UNITED STATES PATENT AND TRADEMARK OFFICE

Office Action Summary

09/515,266

RILEY, CARL WILLIAM

Figure 1 – Bi-directional Optically Powered Signal Transmission Apparatus –

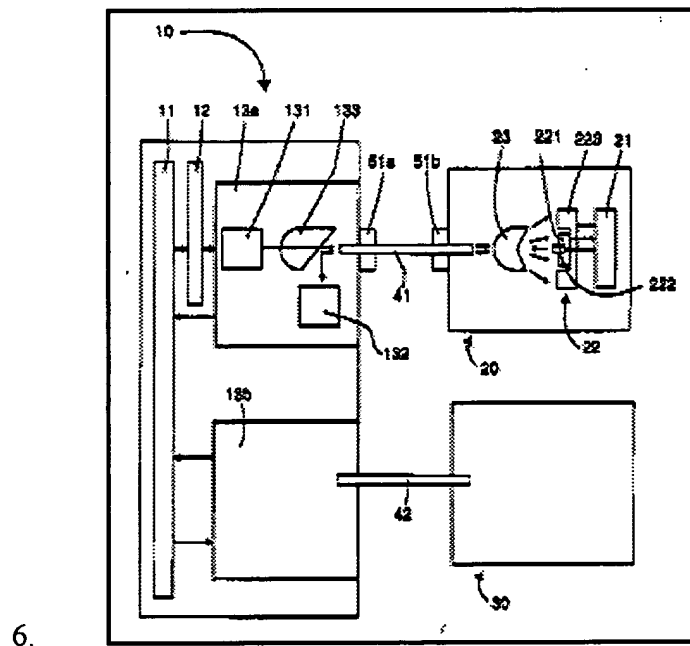
7. **As per claims 1 and 71**, Tsuji et al. disclose an apparatus (and method) comprising: an optical channel (41) having a first end (i.e. Fig. 1, near connector 51a) and a second end (i.e. Fig.

1, near connector **51b**) a light source (**131**) adjacent the first end for transmitting light through the optical channel; a detector (**223**) adjacent the second end producing electrical power when impinged upon by the light; a signal generator (**222**; column 4, lines 41-43) adjacent the second end powered by the electrical power generated by the electrical power from the detector (column 4, lines 55-58), the signal generator transmitting optical signals in response to input from a remote isolated circuit (see Fig. 1, **10**), the input being generated by a user of the remote isolated circuit; a sensor (**132**) adjacent the first end (i.e. Fig. 1, near connector **51a**) for producing electrical signals in response to the optical signals(column 5, lines 35-36).

8. **As per claim 2**, Tsuji et al. disclose an apparatus comprising a fiber optic filament (**41**, **42**).

9. **As per claim 4**, Tsuji et al. disclose an apparatus comprising lenses (**133**, **23**).

Figure 2 – Bi-directional Optically Powered Signal Transmission Apparatus –

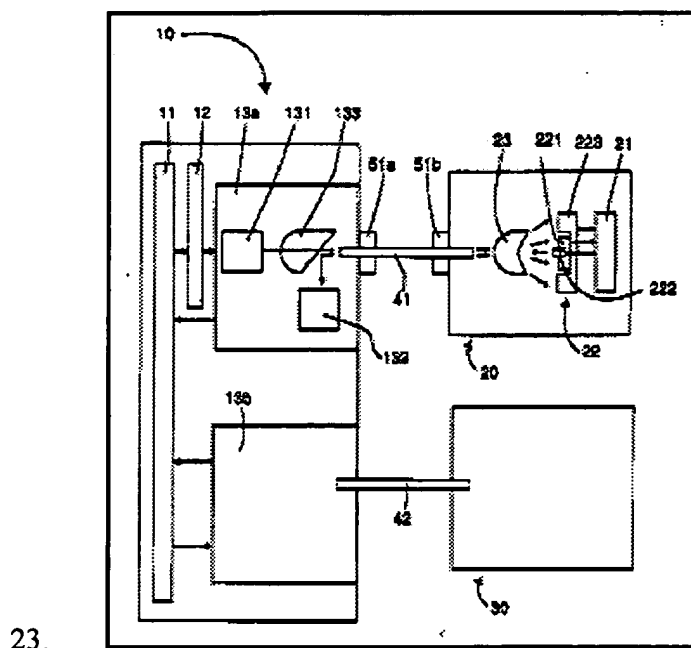
24. As per independent claims 62 and 73 and dependent claims 61 and 63-69, the prior art teaches a system (and method of operation) comprising. an optical channel (41), a light source (131) for transmitting light in a first direction through the channel (41), a detector (223) for producing power in response to the transmitted light, an optical signal generator (222) for converting the input signal from a remote circuit (10) to an optical signal, the signal generator (222) transmitting the optical signal through the channel (41).

25. The examiner however, found no reference in the prior art that disclosed or made obvious a system comprising an actuator controlled by a controller and wherein a source circuit controller responds to an electrical signal by causing the actuator to perform a task corresponding to the input signal from the remote circuit as recited in independent claim 73.
